STAFF REPORT
DATE: 3/12/2023
WORKSHOP DISCUSSION

TO: City Council
FROM: Nathan Fuerst, AICP, Consulting Planner
AGENDA ITEM: **Sketch Plan Review – Limerick Village**
REVIEWED BY: Jason Stopa, Community Development Director
Clark Schroeder, Interim City Administrator

RE: Limerick Village Sketch Plan Review

INFRASTRUCTURE PLAN W/ AERIAL

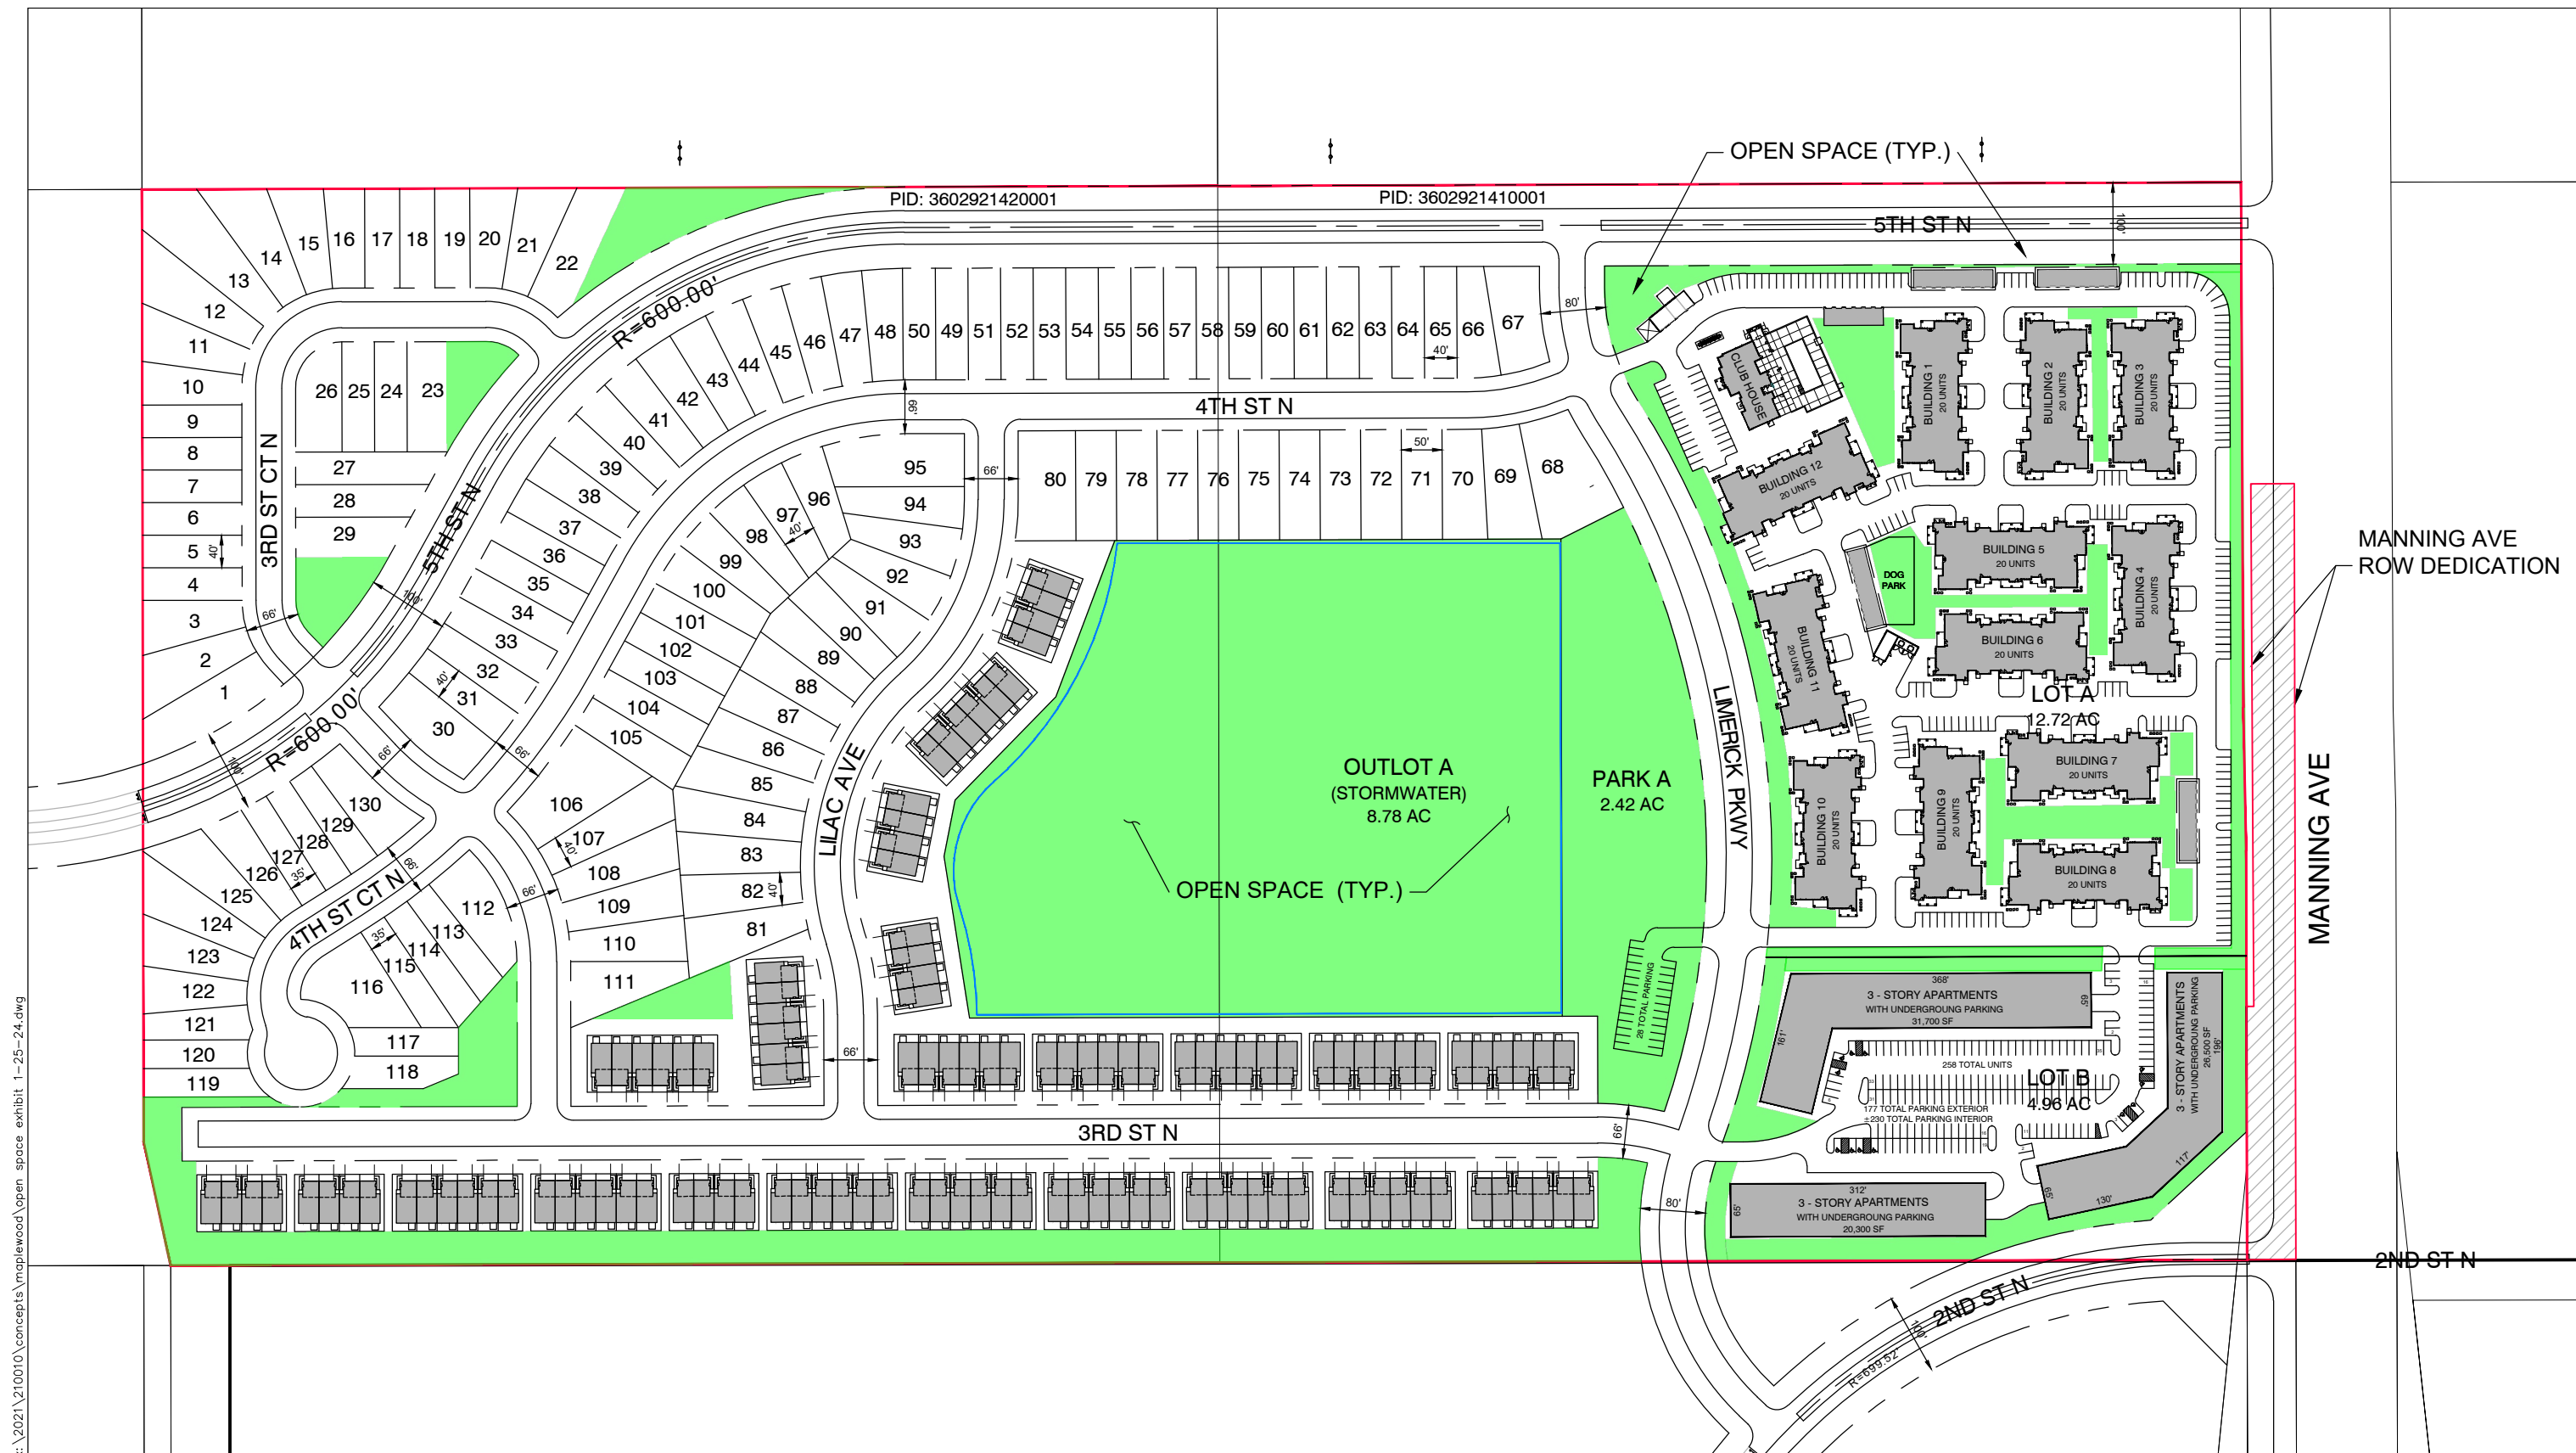
2. The Limerick Village Infrastructure Plan shows the required Hudson Boulevard and sanitary sewer improvements to support the development consistent with the City's requirements, however the plan comments indicate the improvements are to occur at the time of the Limerick Village Project without any indication of who would be responsible for the improvements. The Limerick Village Infrastructure Plan should be revised to clarify that all off-site public improvements are the responsibility of the developer and will be part of the Limerick Village Project.

3. Sanitary sewer must be extended and connect to the existing 24-inch sanitary sewer located along Hudson Boulevard on the east side of the Stillwater Bus facility. The extension must be completed as part of the proposed subdivision improvements in accordance with the previously approved design for Four Corners 2nd Addition. Sanitary sewer will need to be extended throughout the property in a manner that will facilitate the future connection to sanitary sewer to Cimarron and the Oak-Land Middle School. The Limerick Village Infrastructure Plan depicts the trunk sanitary sewer extension to the development parcel as required.

6. The alignment of Hudson Boulevard with 2nd Street will require the elimination of the existing Hudson Boulevard intersection with Manning Avenue as shown on the Limerick Village Infrastructure Plan. These two intersections cannot coexist as active intersections.

4. The project narrative and Limerick Village Infrastructure Plan indicates that the relocation of Hudson Boulevard at Manning Avenue (CSAH15) is consistent with the Four Corners 2nd Addition Plans prepared by Larson Engineering. Any plan submittal going forward must include the Hudson Boulevard realignment plans as approved by the city will no deviations, including lane configurations, clear zones, pedestrian facilities, turn lanes, and typical sections.
